Note / Memo HaskoningDHV UK Ltd.

To: North Hertfordshire District Council

Our reference: PC1534-RHD-NT-0001-NT-0001

Subject: Planning Application Ref: 20/00744/OP - Review of Transport Assessment

Note – use of Drawing 001220-JPL-ZZ-XX-DR-D-2001 for clarity only. No liability taken for accuracy of base drawing.

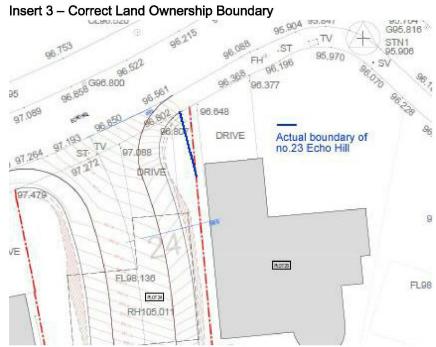
It is proposed to achieve a vehicular access to the site by acquiring and demolishing no 24 Echo Hill. Drawing 001220-JPL-ZZ-XX-DR-D-2001 from the TA shows the proposed alignment of the new access road into the site. Review of the drawing reveals a number of concerning issues with design, including:

- Delivery of the access appears to require access to the rear gardens of no.s 23 and 25 Echo Hill
 in order to install the proposed retaining walls (see section at chainage 35m);

- The red line also includes part of the front garden of no. 23 Echo Hill (see Insert 3);
- The access road would enter the site below grade. No evidence has been provided how the internal roads could meet design standard;

- No details are provided regarding the proposed drainage of the access road. Given the access is lower than the on site drainage features it is expected that the existing highway drains on Echo Hill will be used. It is unknown whether the Echo Hill drains have spare capacity;

- No dimension is shown of the Echo Hill carriageway where it meets the proposed access road;
- No dimension is shown of the distance between the proposed access road and the adjacent junction providing access to no.s 10 to 22 Echo Hill

- The driveways of no.s 23 and 25 are immediately adjacent to the tie in to the proposed junction, reducing visibility;
- No visibility splays are shown on the drawing;

- No line markings are proposed to restrict parking in vicinity of the junction; and
- No swept path analysis has been undertaken to demonstrate the access can accommodate the largest anticipated vehicles.

It is understood that neither no.23 or 25 Echo Hill are owned by the applicant. Neither household has agreed to allow access to their land. In this situation the applicant has no way of delivering the proposed access; the proposals are fundamentally undeliverable.
